26 July 2024

**Subject: SGP North EA (EA0001399) major amendment application response to the Request for Further Information (RFI) (reference A-EA-AMD-100565408)**

**Table 1 Request for Further Information (RFI) and response from Arrow Energy**

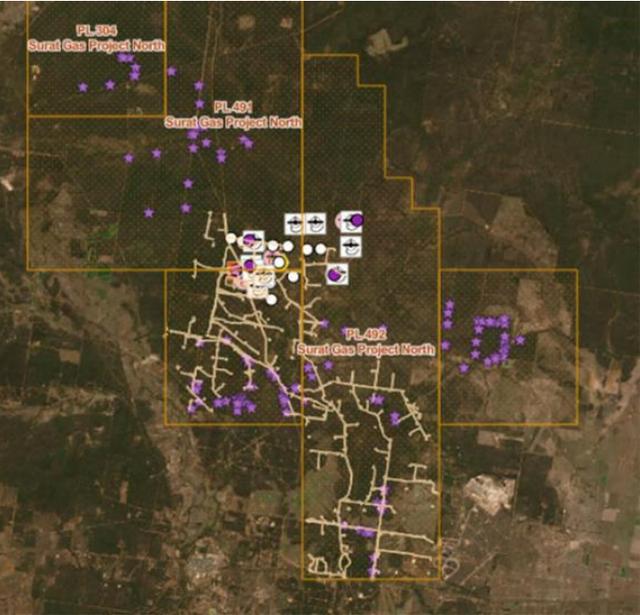
Item	Issue	Action required	Arrow Energy's response
			<p>of pad construction and rehabilitation for other wells are the same as for “production wells”</p> <p>All wells which are not immediately plugged and abandoned but are operated for a period of time require periodic operation and maintenance activities. The potential impacts during operation are the same as for “production wells” (i.e. sediment and erosion, surface contamination from leaks from equipment etc). Exploration wells are typically plugged and abandoned immediately after drilling.</p> <p>All wells are drilled and constructed using similar methods and have similar potential impacts as for production wells (i.e. connection of aquifers, loss of drill fluids etc). To manage this, all well types are drilled to the Code of Practice for the Construction and Abandonment of Petroleum Wells and Associated Bores in Queensland (State of Qld, 2019). The purpose of this Code is to ensure that all petroleum wells and associated bores are constructed, maintained and abandoned to a minimum acceptable standard resulting in long-term well integrity, containment of petroleum and the protection of groundwater resources. This Code identifies industry standards and good oilfield practice for oil and gas well design. Well integrity is fundamental to ensuring sustainable petroleum production, ensuring risk can be managed to an acceptable level and protecting aquifers during the well life cycle. This Code addresses safety and environmental issues in the construction, operation and abandonment (decommissioning) of petroleum wells and associated bores.</p> <p>In addition to potential subsurface impacts from construction and abandonment of the wellbore itself, operation of wells to produce water and gas has potential environmental impacts. These potential impacts are to water availability and quality of groundwater systems and associated environmental values including adjacent aquifers, springs, groundwater dependent ecosystems, conjunctive use of groundwater such as landholder bores, and surface water systems through connectivity.</p> <p>The impacts to surface infrastructure associated with the different types of wells is that for an exploration well/core holes, these would likely require the same surface footprint of a production well of around 1 ha, but the above ground infrastructure would be limited to a cap or riser. A production well on a 1ha well pad would have additional surface infrastructure including the well head, well skid, hydraulic power pack unit/generator and manifolds for the gas and water. With regards to monitoring wells, these may be collocated on an existing production or exploration well pad and will consist of a pressure gauge at the surface or some telemetry devices.</p>

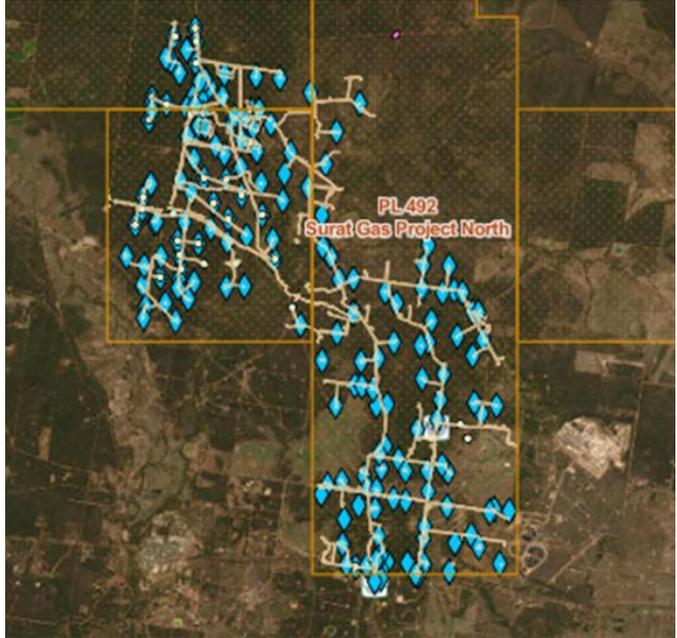
Coal Seam Gas (CSG) Wells	Quantity	Well Type	Quantity	Existing or Proposed	Total authorised under EA0001399	588	Production wells	588	Proposed	From appraisal and monitoring activities conducted	56	Exploration/Core wells	35	Existing	Monitoring wells	21	Existing	Proposed for SGP North Stage 1 Development	214	Development/ Production wells	214	Proposed	11	Monitoring	11	Proposed
Coal Seam Gas (CSG) Wells	Quantity	Well Type	Quantity	Existing or Proposed																										
Total authorised under EA0001399	588	Production wells	588	Proposed																										
From appraisal and monitoring activities conducted	56	Exploration/Core wells	35	Existing																										
		Monitoring wells	21	Existing																										
Proposed for SGP North Stage 1 Development	214	Development/ Production wells	214	Proposed																										
	11	Monitoring	11	Proposed																										
16.	<p>The application states the RoW width for co- located facilities will be up to 40m. It states this excludes the Girrawheen to Bellevue pipeline RoW, with a combined pipeline width of up to 47m.</p> <p>Further, in section 1.5 of the Supporting Information Report, the application states the 20km RoW required for the gathering lines, access tracks for wells and the water transfer export pipeline, from Girrawheen Field Compression Station to the southern limit of PL492, will be 27m in width.</p>	1. Clarify the pipeline dimensions accounted for in the proposed amendment and surface disturbance areas.	<p>1. The spatial files and disturbance to PEMS has been calculated based off "issued for design" concepts which takes into consideration number of pipelines and pipeline diameter and other infrastructure. This will depend on where the gathering lines are located, with smaller diameter pipes required closed to the well head, and larger diameter where the gathering lines act as header lines. Please refer to section 4.6 of the SGP North EA amendment application supporting report and 4.6.3 which details this (refer to <b>Appendix A</b> of this RFI response). Arrow Energy's preferred method of laying gas and water gathering lines is by direct installation using standard pipeline trenching methodologies.</p>

Item	Issue	Action required	Arrow Energy's response
		<p>2. Confirm that plans to co-locate impacts with the Girrawheen to Bellevue pipeline RoW and any other RoW authorised under separate EAs are excluded from the considerations surrounding surface disturbances in this application.</p>	<p>This involves the following:</p> <ul style="list-style-type: none"> <li>• Right of way (RoW) clearance, including vegetation clearing and topsoil stripping;</li> <li>• Pipe stringing: small diameter pipe (up to 160 mm) via coils, large diameter pipe via 21 m lengths;</li> <li>• Pipe welding to join supplied lengths into networks;</li> <li>• Trenching, pipe lowering and trench backfilling/compaction;</li> <li>• Pneumatic pressure and leak testing;</li> <li>• RoW rehabilitation including top soil re-instatement; and</li> <li>• Regular communication with affected landholders and patrols to monitor any subsidence for repair.</li> </ul> <p>Multiple work crews will progressively execute construction. Depth of pipe burial will comply with the requirements in the APGA Code of Practice for Upstream Polyethylene Gathering Networks – Coal Seam Gas Industry. Gas and water pipelines are collocated as much as possible.</p> <p>Generally, an average typical RoW width of 22 m is required to allow vegetation clearing, mulching, and stockpiling, stockpiling of subsoils and topsoils, and safe access and movement of personnel and heavy machinery (including trenching machines) and access tracks to the wells. The RoW width is dependent upon the number of gathering lines in the RoW (trenching required), stock piling of additional vegetation clearing, permanent access tracks to wells and work space during construction and/or operational phases.</p> <p>The current practice is an average ROW width of 24 m with a separate permanent access track. Arrow is planning to implement gathering before drilling strategy that will consider converting vehicle work area into access tracks thereby reducing ROW width (10%) with an average typical 22 m.</p> <p>2. Arrow Energy confirms that:</p> <ul style="list-style-type: none"> <li>• the Girrawheen to Bellevue (G2B) pipeline ROW is the only co-located ROW proposed to be authorised under a separate EA in relation to the SGP North Stage 1 development; and</li> <li>• that the disturbance for the G2B pipeline has been excluded from the considerations surrounding surface disturbance in this EA amendment application and forms part of a separate assessment and a new EA application but has taken into consideration cumulative impacts i.e. fragmentation etc.</li> </ul>

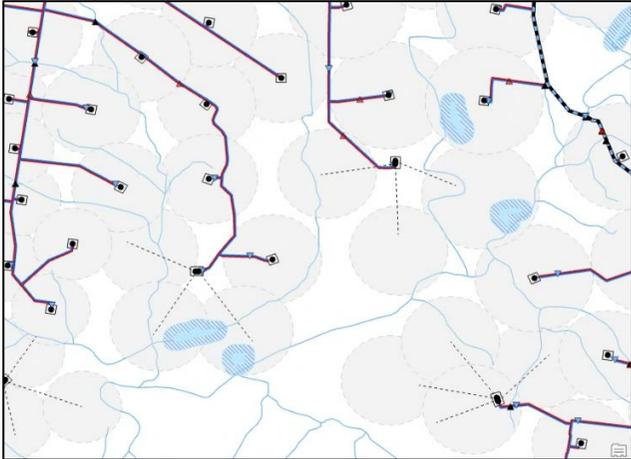
24.	<p><b>Significant residual impact assessment and Cumulative Impacts</b></p> <p>The application does not provide a SRI assessment for PEMs identified as present or as having a likelihood of occurrence within the project area.</p>	<p>1. Taking into account the conclusions of the ecological report, provide a SRI Assessment for each relevant PEM, that addresses the suggested criteria according to the SRI Guideline.</p>	<p>1. The likelihood of occurrence assessment has been updated in the revised BIA report (refer to Section 2.1.2.1 and Appendix D of <b>Appendix L</b> of this RFI response), including the flora / fauna identified in item 21 of this RFI. A summary of the justifications for likelihood of occurrence and inclusion or exclusion from the SRI assessments have been provided in the table in the response to item 21.3 of this RFI.</p>
